ODS BR/KIT S-O HARDWOOD FASCIA

NEWMAR CORP P.O. Box 30, Nappanee, IN. 46550 UNITS: INCHES TITLE BLOCK: 80D	Model:	CSFD 3957	Sheet	1 OF 3	Drawn by:	J. M.	Checked by:	D. E.	Revision: CHANGED FASCIA PART # TO 166904 ILO 166457; CHANGED HEIGHT OF FASCIA TO 7 1/8" ILO 6 1/2";	By: J. M.
	Title:	FASCIA	I.D. # 2024\CA\CAB\FASCIA\CS3957	Date:	9/27/22	Date:	11/15/22	CHANGED RETURN LEG HEIGHT TO 47 7/8" ILO 54 3/8" & 70 7/8" ILO 77 3/8"; UPDATED END CAP DEPTH (2024 ECO #85)	Date:DE 4/12/23	
								Revision: ADDED NEW PART # 166457 ILO 160789 DUE TO CHANGES MADE FROM	By: J. M.	
								PCR #240410 (2024 ECO #30)	Date:DE 2/2/23

DS LR S-O HARDWOOD FASCIA

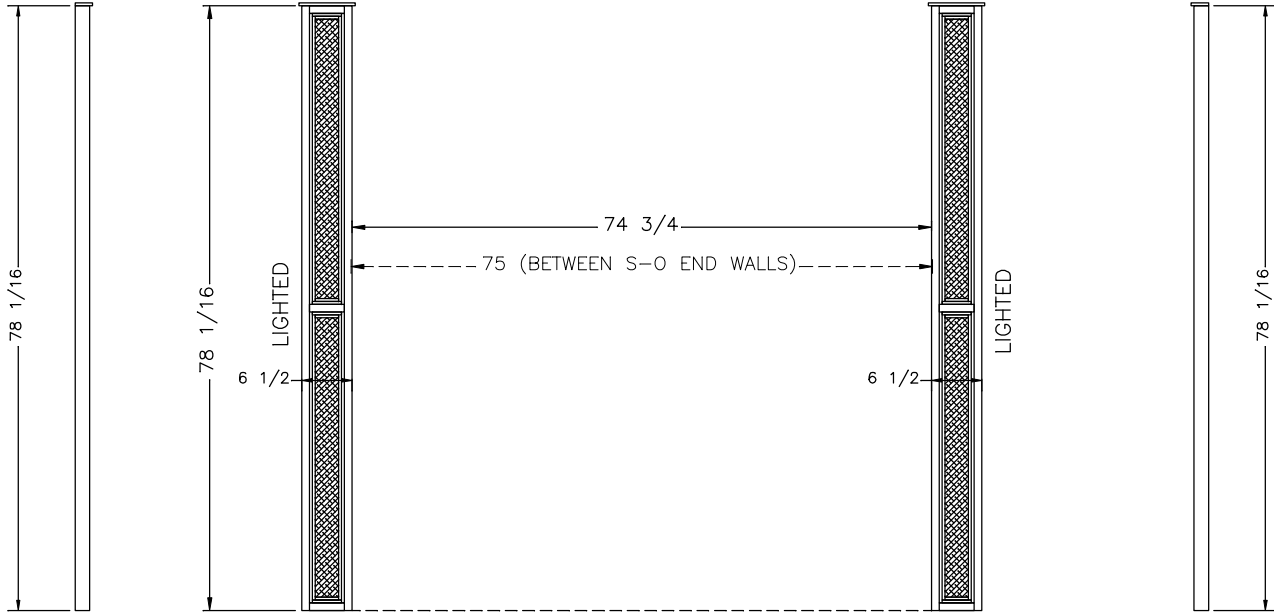
NEWMAR CORP P.O. Box 30, Nappanee, IN. 46550 UNITS: INCHES TITLE BLOCK: 80D	Model: CSFD 3957	Sheet 2 OF 3	Drawn by: J. M.	Checked by: D. E.	Revision: CHANGED FASCIA PART # TO 166904 ILO 166457 (2024 ECO #85)	By: J. M.
						Date:DE 4/12/23
	Title: FASCIA	I.D. # 2024\ CA\CAB\FASCIA\ CS3957	Date: 9/27/22	Date: 11/15/22	Revision: ADDED NEW PART # 166457 ILO 160789 DUE TO CHANGES MADE FROM	By: D. E.
					PCR #240410 (2024 ECO #30)	Date:DE 2/2/23

BEDROOM S-O HARDWOOD FASCIA

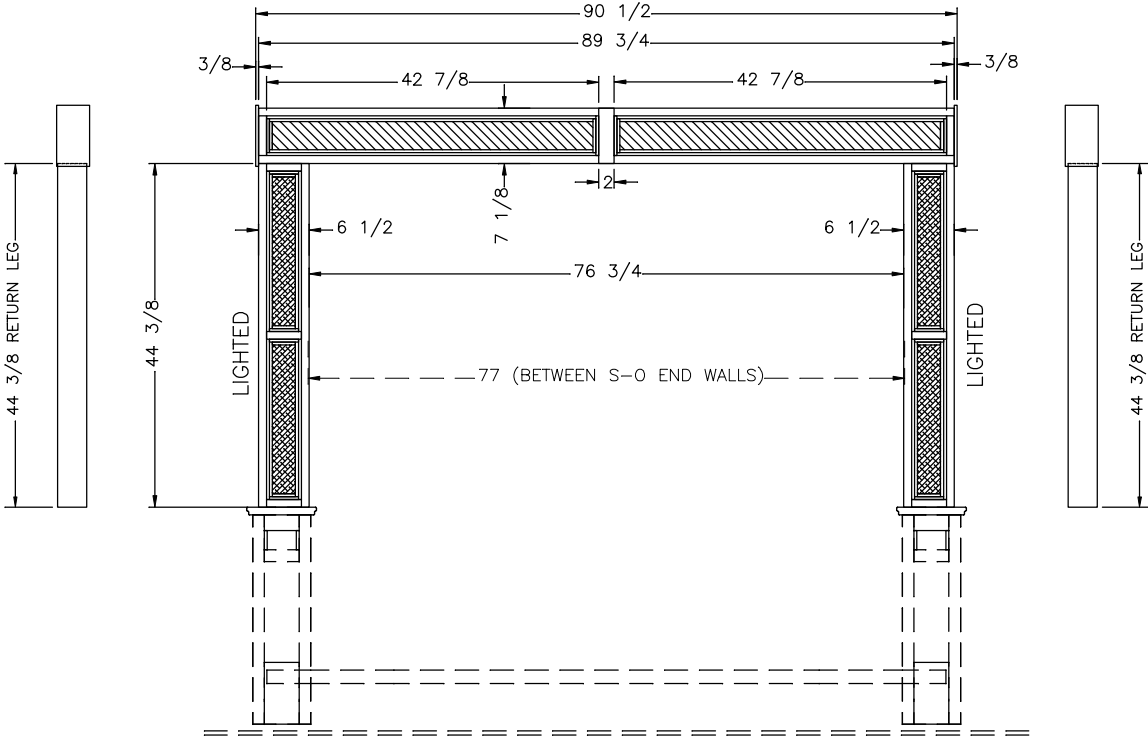
NEWMAR CORP P.O. Box 30, Nappanee, IN. 46550 UNITS: INCHES TITLE BLOCK: 80D	Model: CSFD 3957	Sheet 3 OF 3	Drawn by: J. M.	Checked by: D. E.	Revision: CHANGED FASCIA PART # TO 166904 ILO 166457; CHANGED HEIGHT OF FASCIA TO 7 1/8" ILO 6 1/2";	By: J. M.
					CHANGED RETURN LEG HEIGHT TO 44 3/8" ILO 50 7/8"; UPDATED END CAP DEPTH (2024 ECO #85)	Date:DE 4/12/23
	Title: FASCIA	I.D. # 2024\CA\CAB\FASCIA\CS3957	Date: 9/27/22	Date: 11/15/22	Revision: ADDED NEW PART # 166457 ILO 160789 DUE TO CHANGES MADE FROM	By: D. E.
					PCR #240410 (2024 ECO #30)	Date:DE 2/2/23
